### ADDENDUM FOUR

Memorial Park Improvements 604 Hazel Street Auburn, IN 46706

Commission No.: F23059

Addendum Date: 20 August 2024

Sheet C800 - ADD following note to detail 6/C800:

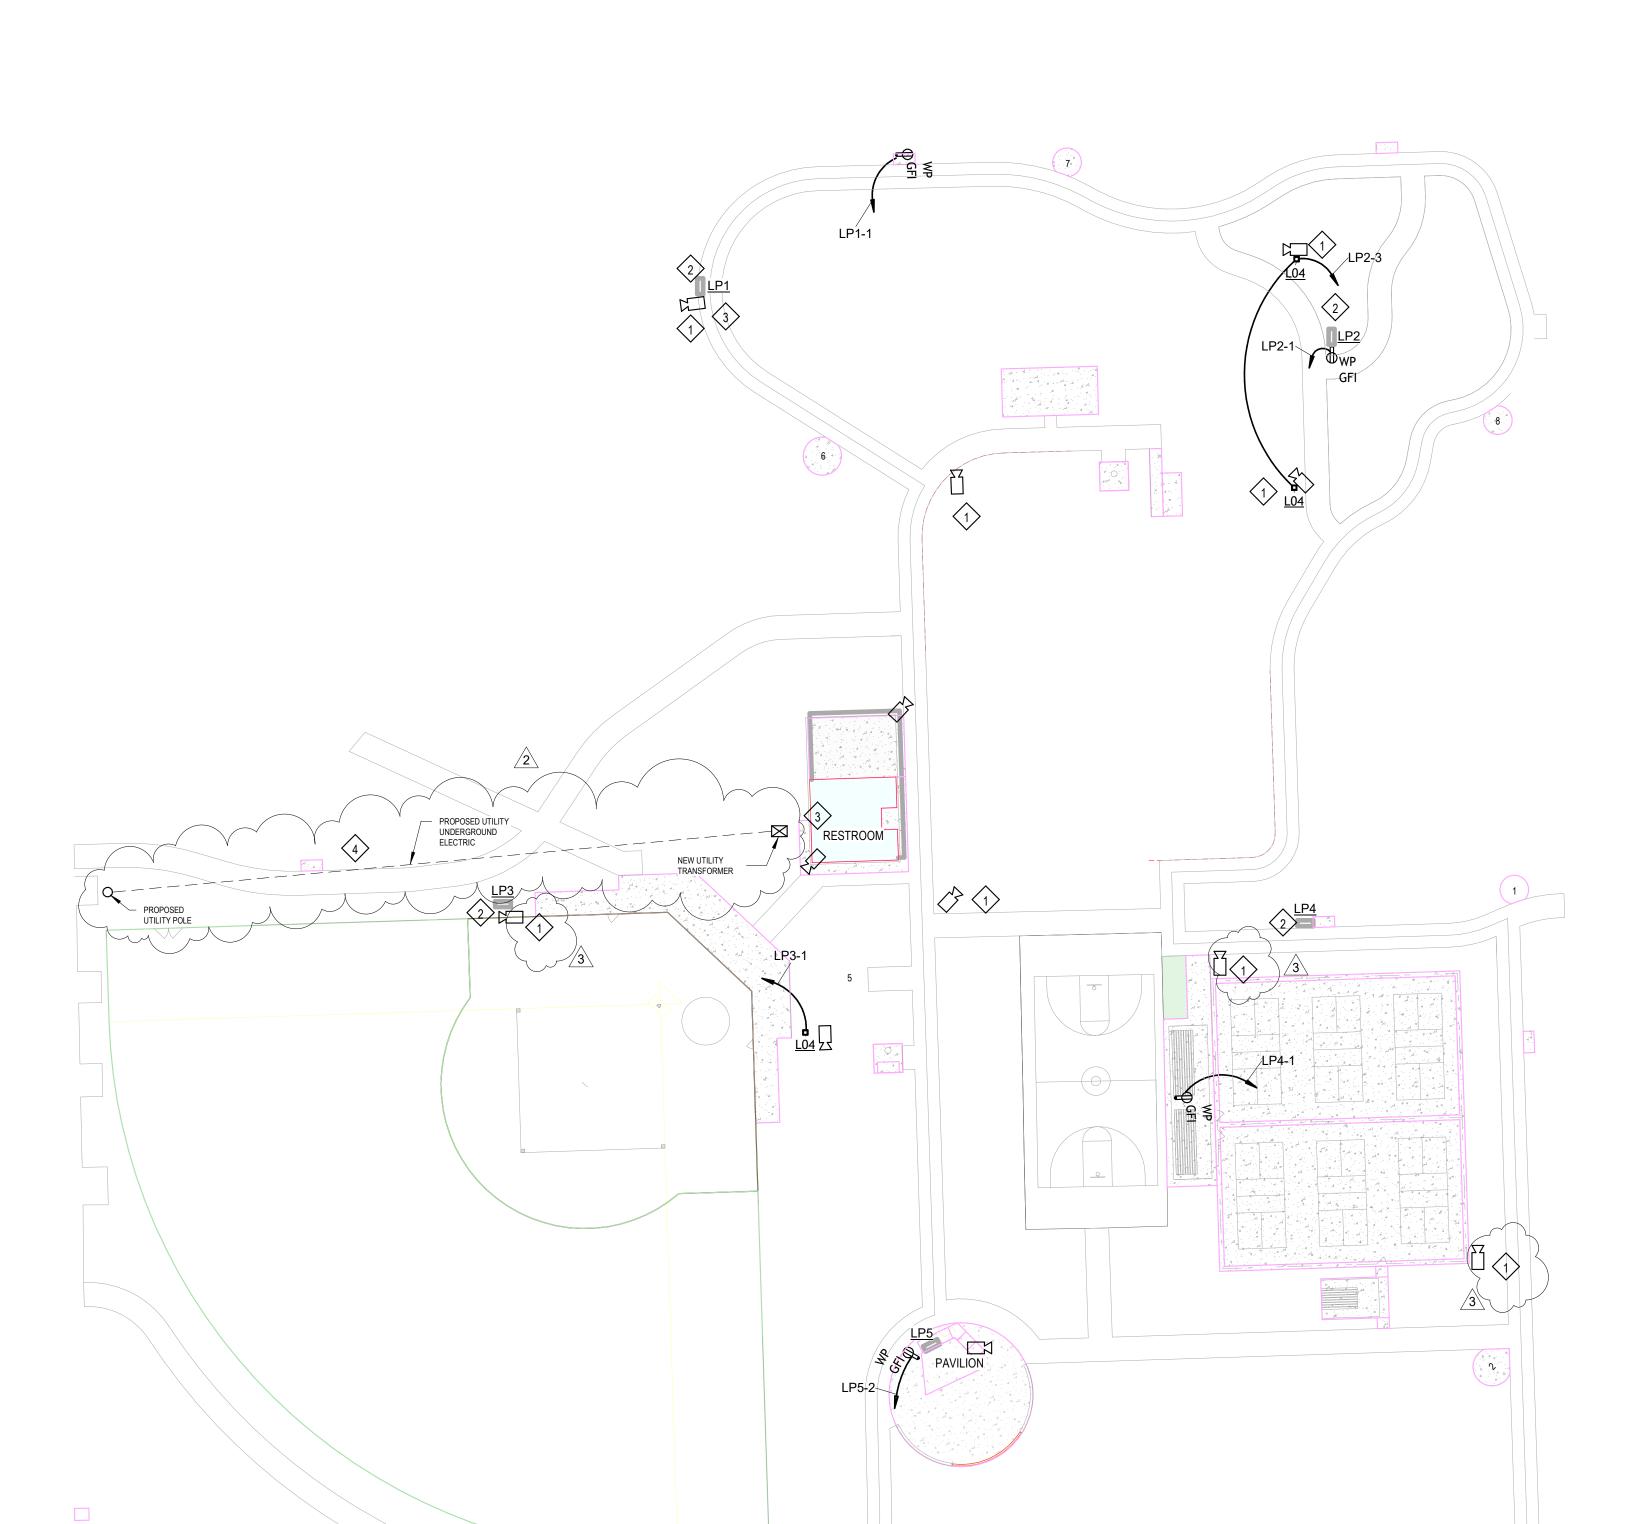
There are no specifications for the color coat system on the pickleball courts, only the color scheme. Can you clarify what you want?

- NOTE: Pickleball Court System
  - (2) 6-mil vapor barrier layers prior to cable placement.

Medium Broom Finish and acid etched

Pressure wash surface and allow to dry before applying Color System.

**Ensure Level**

Basis of Design:

Laykold Colorcoat System - Installed according to the manufacturer's instructions

Lavkold Bond-Kote

Laykold Acrylic Resurfacer

Laykold Topcoat

Laykold Line Primer and Textured White Line Paint
